Planning, Zoning and Building Department

BOARD ACTION REPORT – APPEALABLE ITEM

Project Name: 1020 Langer Way
Project Location: 1020 Langer Way
Request: Class V Site Plan
Board: Site Plan Review and Appearance Board
Meeting Date: December 14, 2016

---STAFF REPORT---

SITE PLAN

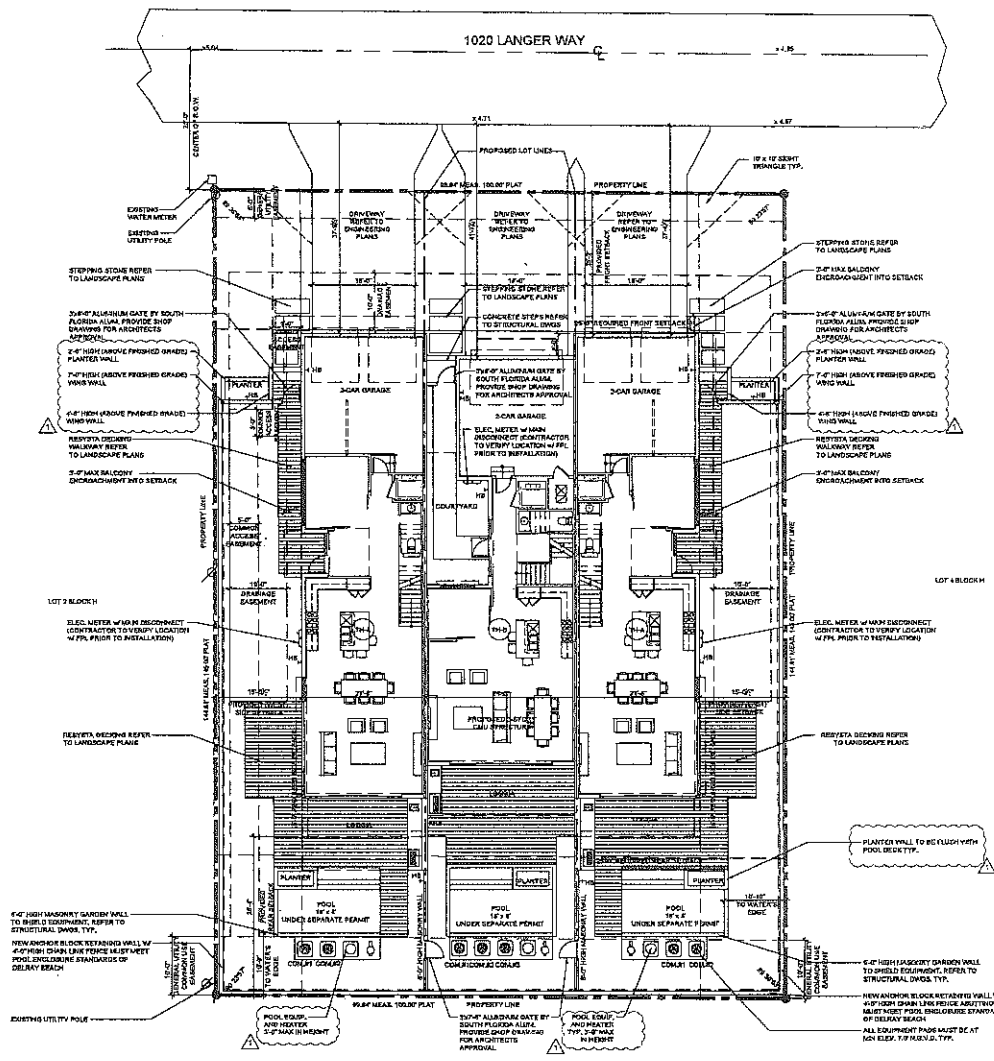
2. The Site Plan and Engineering Plans show numerous easements and appears to split the property into 3 sub-parcels. A plat to create these parcels, easements, and to identify who the easements and parcels are in favor of.

3. The plan sheet needs to show the location of the nearest driveway or point of access of adjacent properties (including property across a street, which shares a common street with the subject property). If there are no driveways within 50', then they do not need to be shown; however, a note to this situation shall be provided.

4. The water meter for the site appears on the survey to be located in the NW corner of the site and not on the NE corner as shown on the Civil Plans.
5. The note on the Paving and Drainage Plan states that "contractor to verify size, material & location" of the water service. The size of the existing water meter must be verified prior to site plan approval as a 5/8" or 1" meter will not be sufficient for three three-story structures.

HARDSCAPE
PLAN

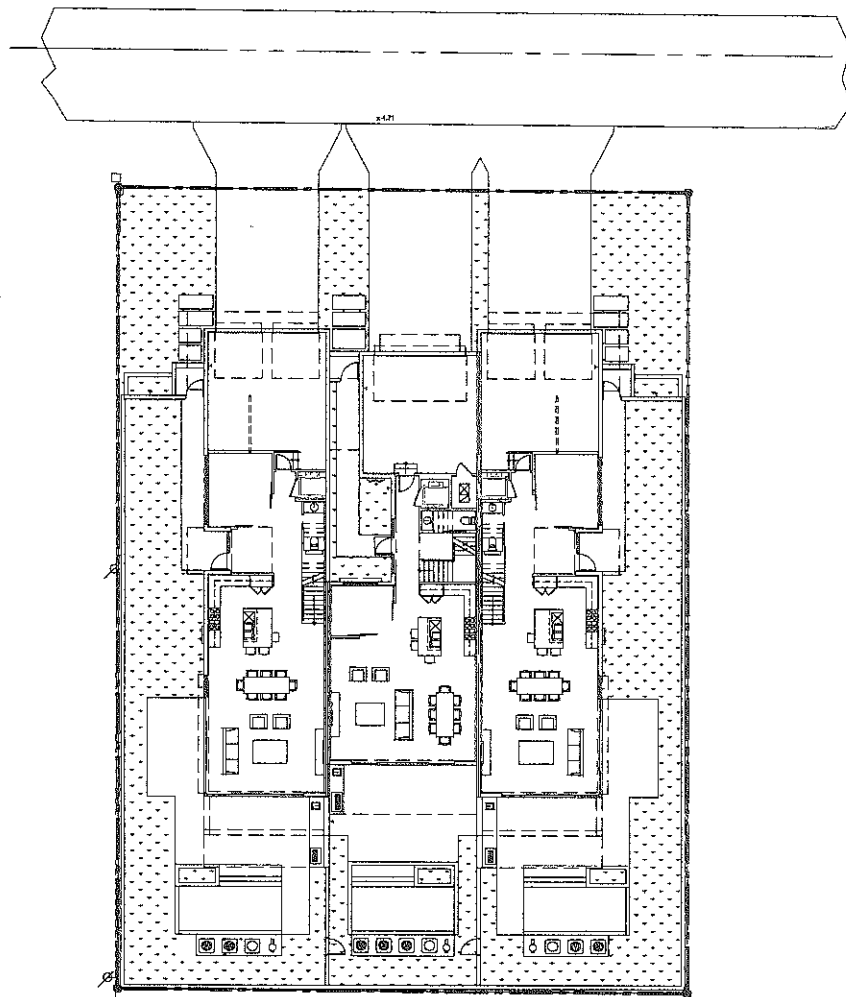
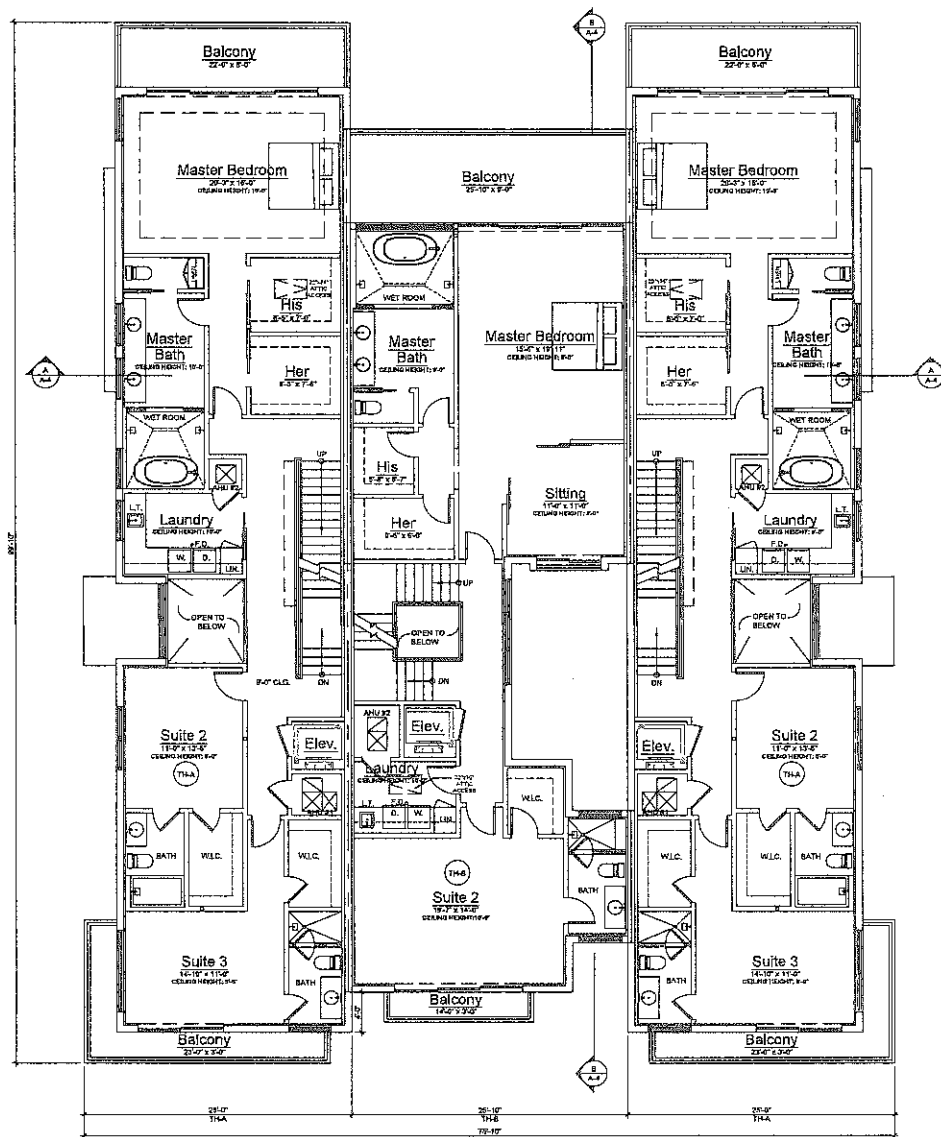
8. A detail is provided for trench drain but it does not appear on the plan. Is it intended to be placed somewhere?
9. As there is currently no sidewalk on Langer way, it would be inappropriate to construct a sidewalk concurrent with development. The applicant must fund the cost of constructing the sidewalk In-Lieu of constructing the sidewalk along the project frontage. These funds will be escrowed and used for the installation of the sidewalk by the City at a later date.
